MAYOR & COUNCIL COMMUNICATION

DATE: July 22, 2014
REGULAR
ITEM #1
RESOLUTION 2014-61

AGENDA ITEM: Lakewood Crossing Preliminary Plat and Final Plat; Kwik Trip Conditional Use Permit

PLANNING COMMISSION
DATE: 7/14/2014
AGENDA ITEM: 4A – PUBLIC HEARING
CASE # 2014-37

DRAWN BY: JTR/KMM
SCALE: GRAPHIC
PROJECT NO.: 4982-00
DATE: 2014-05-09
SHEET: SP4

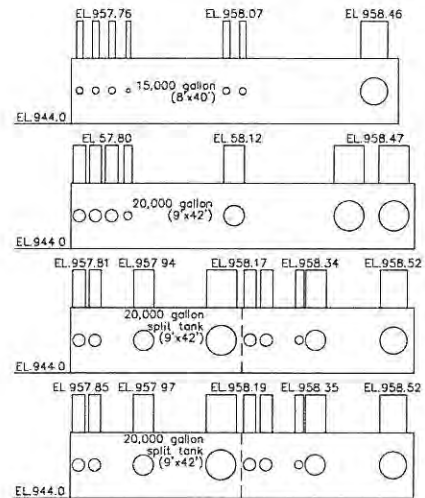
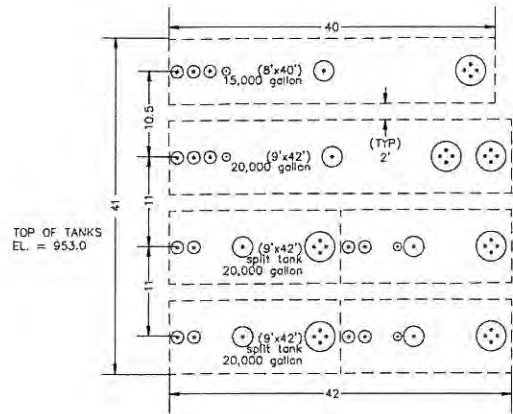
1. The drainage and utility easements must be placed on both the utility plan, Sheet SP4, and the grading plan, Sheet SP3 to demonstrate sufficient easement is being provided. A minimum 15 feet of utility easement is required from the centerline of the proposed watermain utility. It appears additional easement is required.

1. City Standard Plan Notes for Watermain, Detail 200A, for Sanitary Sewer, Detail 300A, and for Storm Sewer, Detail 400A, must be placed on the Utility Plan, Sheet SP4. All other conflicting information must be removed. Supplemental notes may be provided if not already addressed by the City standards.

DRAWN BY	ELF
SCALE	GRAPHIC
PROJ. NO	4982-00
DATE	2014-05-05
SHEET	L1

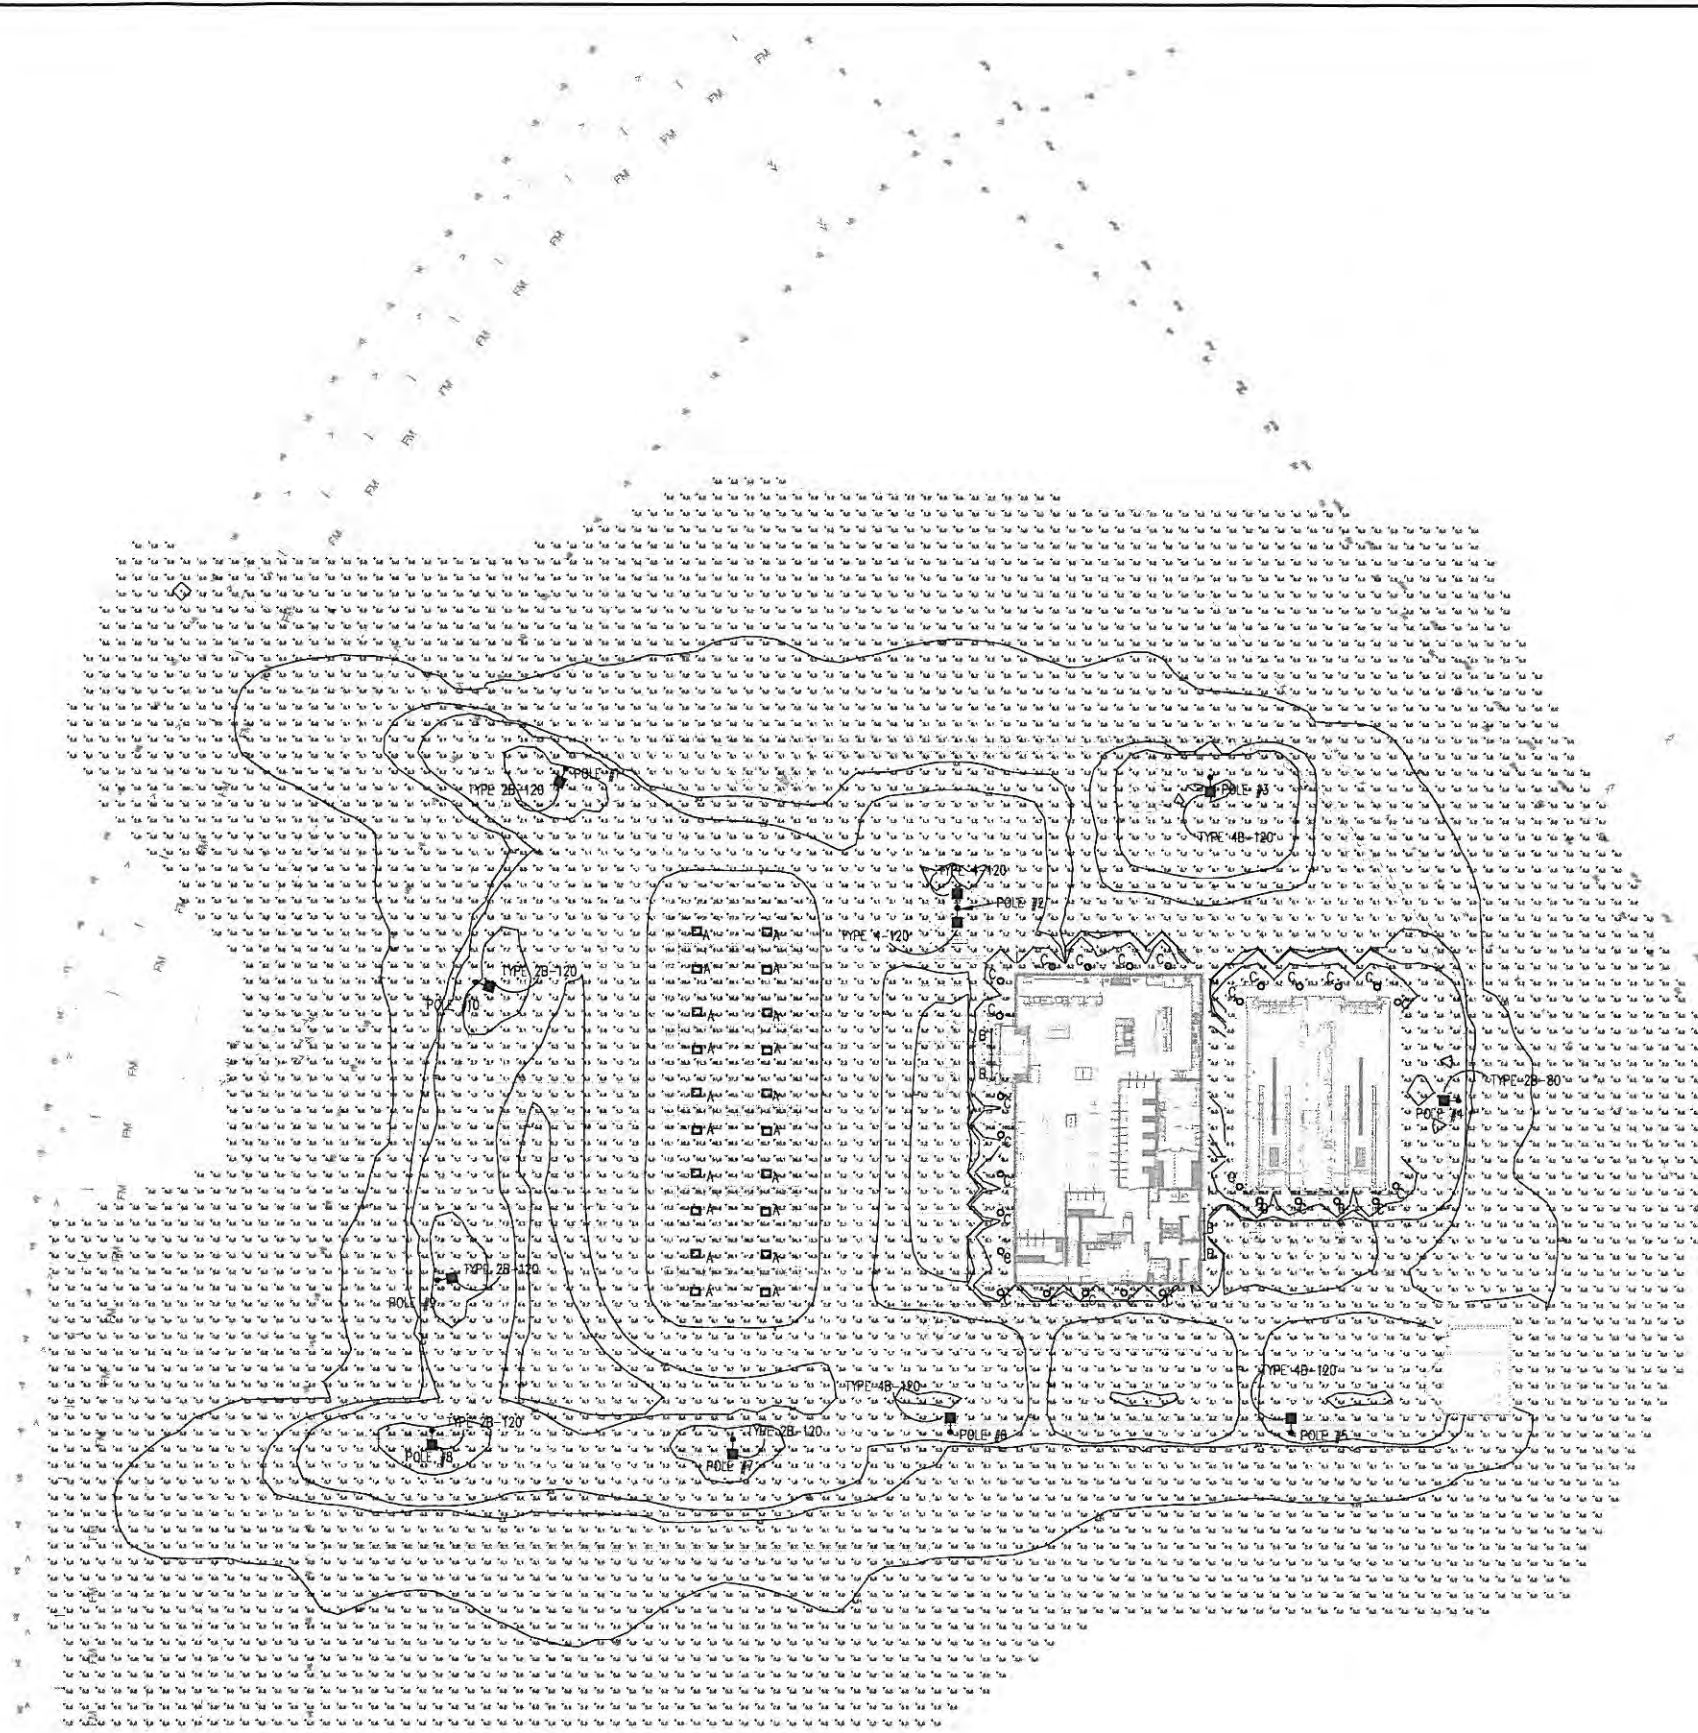
- **Landscaping.** The applicant has submitted a Landscape Plan (Sheet L1) as part of the proposed gasoline station. The City's landscaping provisions (§154.258) require 1 tree per 50 feet of street frontage. In addition to street plantings, the City's requirements include 5 trees per developed acre. Given these requirements, staff calculated that 15 street trees are required (based on approximately 780 feet of street frontage on Hudson and Keats) and 10 interior trees are required (5 trees per acre). The total required amount of trees per staff's calculation is 25 trees. The applicants are proposing 25 trees of both deciduous and coniferous varieties, meeting the City's requirement. It should be noted that the coniferous trees are being utilized to screen the trash or refuse area. In addition to the trees, the applicants are proposing a variety of shrubs and planted beds. Finally, staff has distributed the Landscape Plan to the City's Landscape Consultant, Stephen Mastey. Staff would recommend as a condition of approval (Condition #5) that the Landscape Plan be reviewed by the Landscape Consultant. In addition to review, staff would recommend that any modifications related to plant species or location be incorporated in the Final Landscape Plan prior to issuance of the building permit.

TURN LANE EXHIBIT

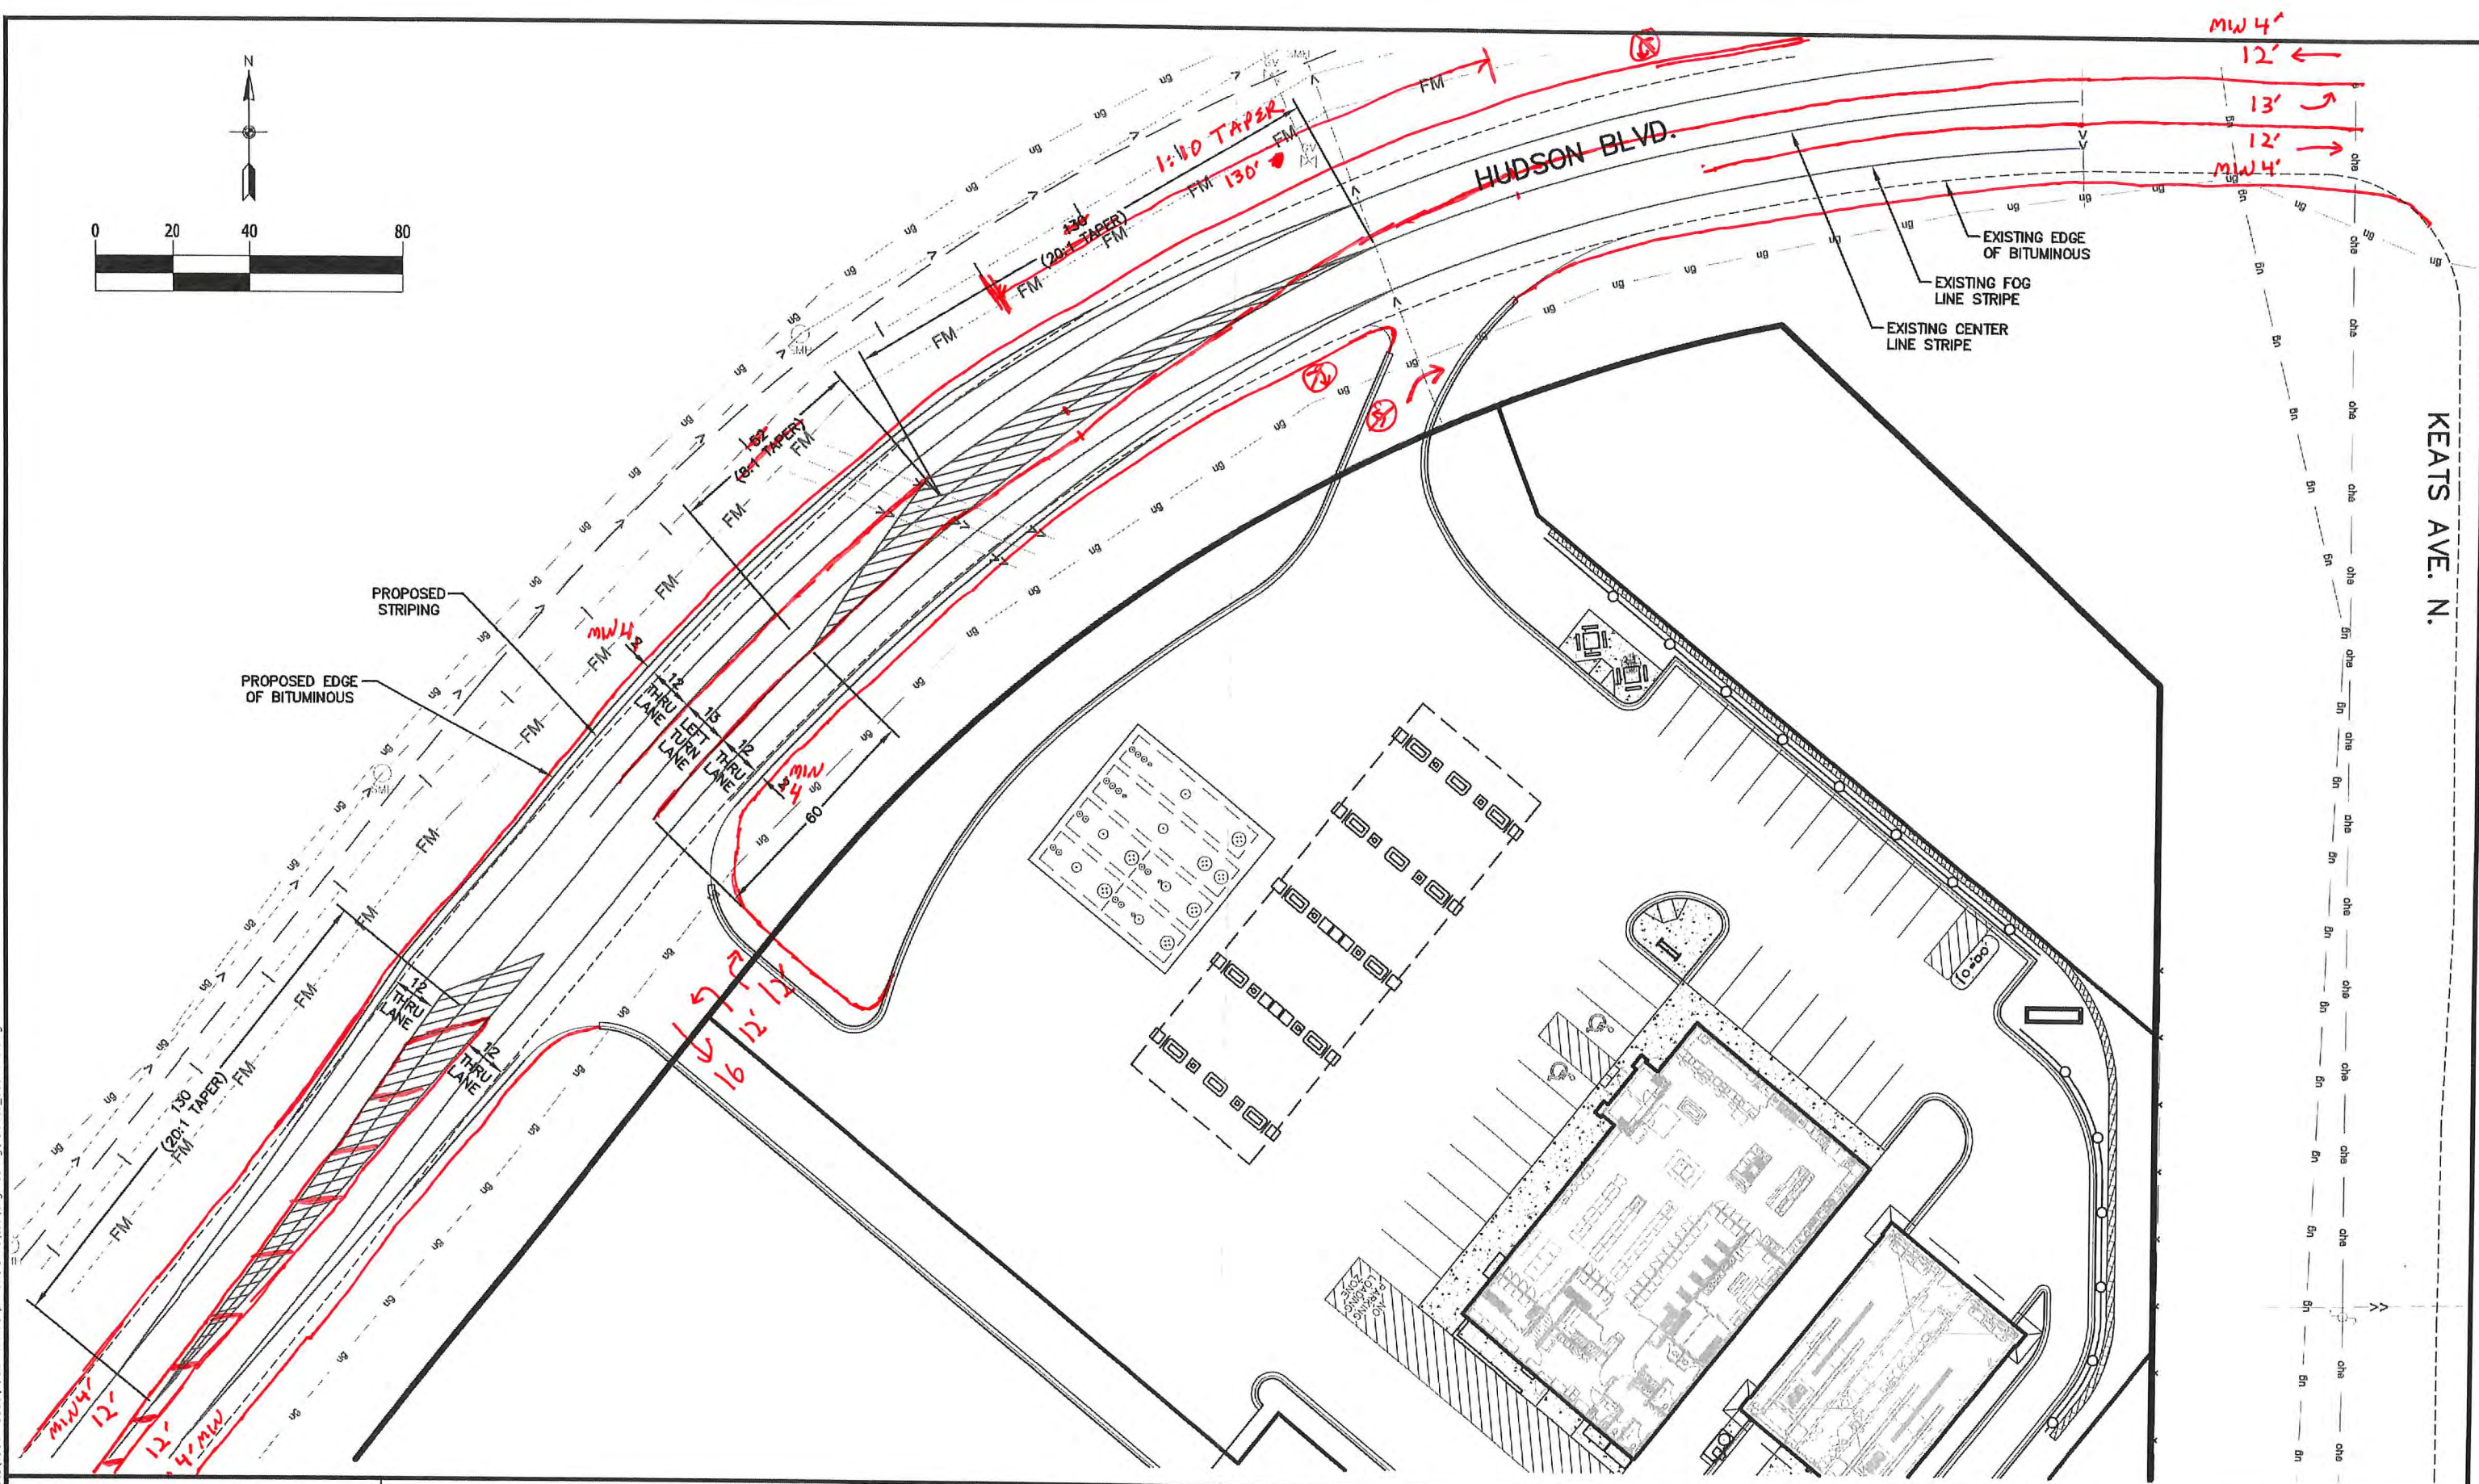
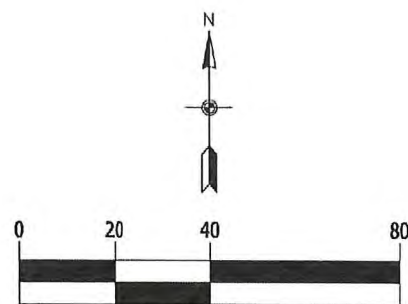
Per your request, we have reviewed the Turn Lane Exhibit for the Lakewood Crossing, dated June 11, 2014, and sent for our review on June 18, 2014. The exhibit shows two points of access for the site, both off Hudson Boulevard. A westbound left-turn lane from Hudson Boulevard into the site is established through restriping and limited pavement widening. The exhibit is attached to this memorandum for reference.

Our review focused on the ingress and egress of the site, particularly the proposed design of the turn lane on Hudson Boulevard. Based on this review, our comments are:

- Keats Avenue is a County State Aid Highway and an A Minor Arterial. The City's 2030 Comprehensive Plan lists an existing average daily traffic of 6,100 vehicles per day on this roadway. Hudson Boulevard is a local frontage road, proposed to be a Major Collector in the future. It has an average daily traffic volume of 1,300 as listed in the City's Comprehensive Plan. The exhibit shows that the site, appropriately, will be accessed from Hudson Boulevard, which is both lower on the hierarchy of roads and carries less traffic than Keats Avenue.

- The west access should be planned for full access into and out of the site. It is proposed to be located farthest from the Hudson Boulevard/Keats Avenue intersection (~550 feet), which will limit the interaction and influence of operations between these two intersections. The width of this driveway should be at least 40 feet to accommodate one inbound lane (16 feet wide) and two outbound lanes (left-turn lane 12 feet wide and right-turn lane 12 feet wide).

RECOMMENDED
REVISED
ACCESS
7-9-2014

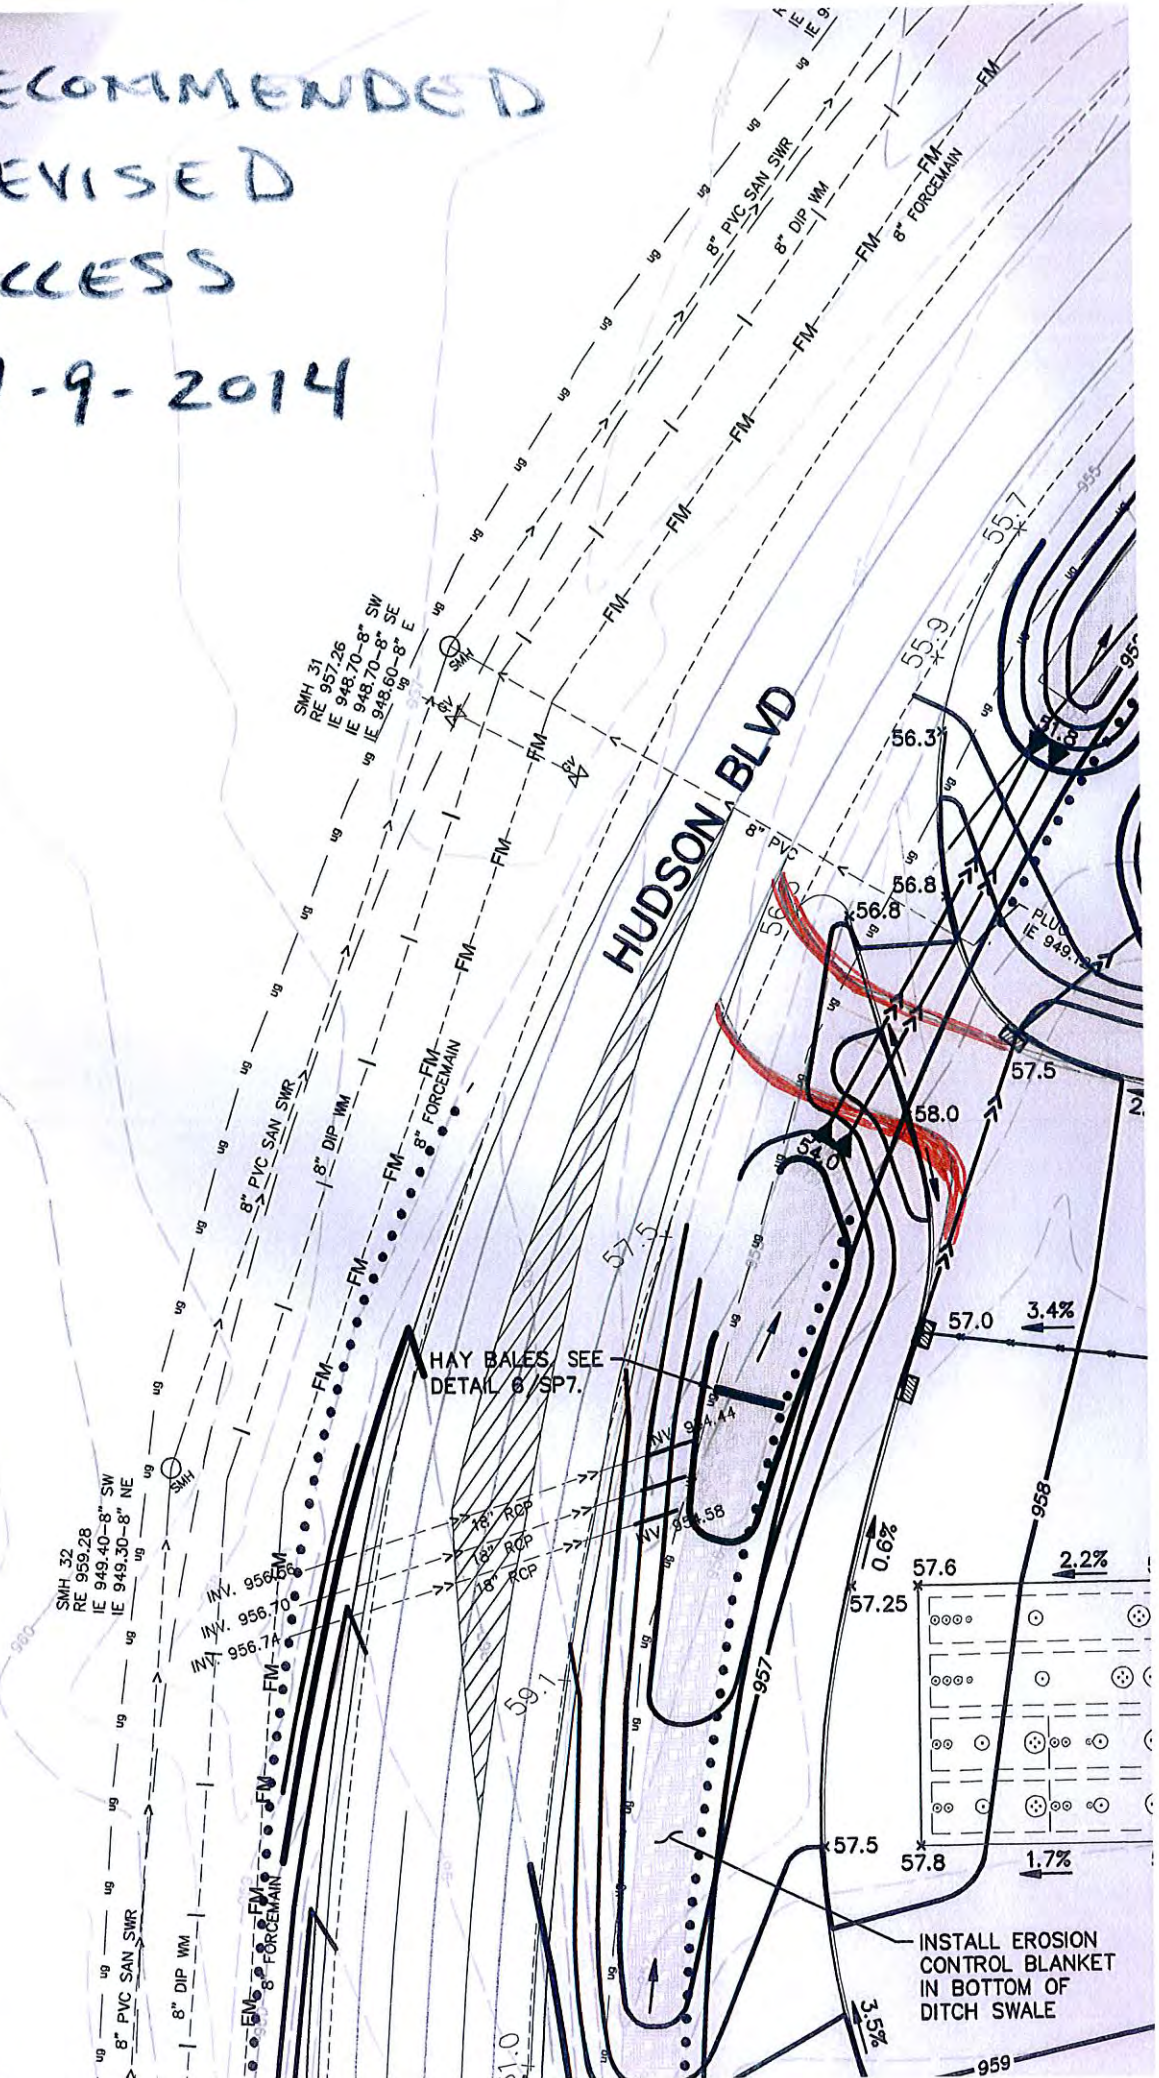
- b. The design of the northeast right-out only access must be revised per the recommendation of the City Engineer and Washington County. The design of the northeast access must be approved by the City prior to the approval of the building permit.

- b. The design of the northeast right-out only access must be revised per the recommendation of the City Engineer and Washington County. The design of the northeast access must be approved by the City prior to the approval of the building permit.
